ADVISORY NOTICE

Document: 4555 / 01

RX2 Relay Possible Incorrect Contact

Product: ZooMax LC Family; Milestone LC Family (*3-phase input version only*)

Milestone LC Generator side view with RX2 relay

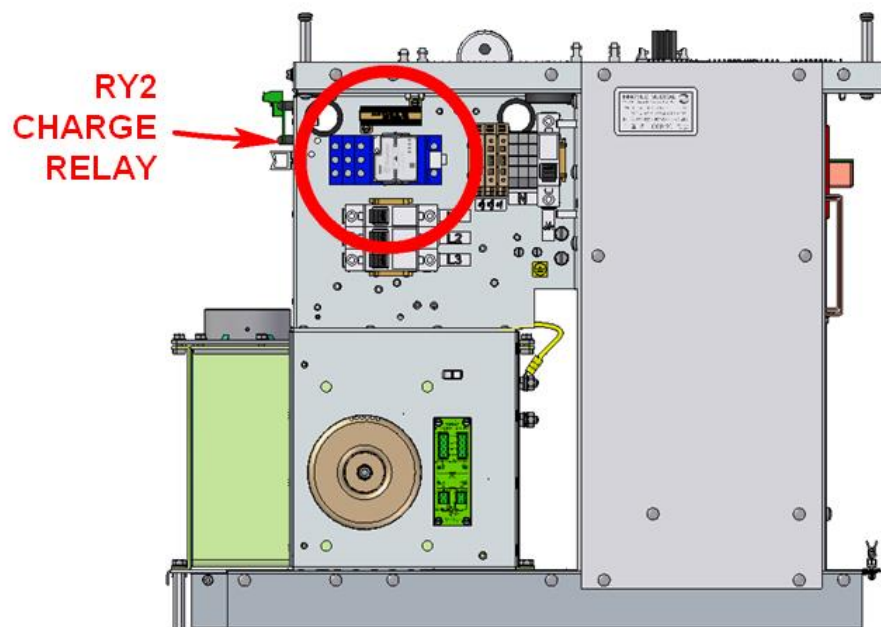
During shipment, the RX2 slow charge relay may become loose preventing the generator from charging the capacitor bank. Either the generator will display WARMING UP... message during startup and cannot go into ready state or it will automatically turn itself off after several seconds.

The RX2 relay is mounted in a standard PTF / PYF socket sideways and is held in place by a wire clip type retaining clip.

1. During installation, make sure that:
 - a. RY2 is seated well in its socket
 - b. and the retaining spring clip holds it firmly in place. If necessary, replace the retaining clip with a compatible type, e.g. SY2S-02F1 (pullover wire spring type, IDEC):
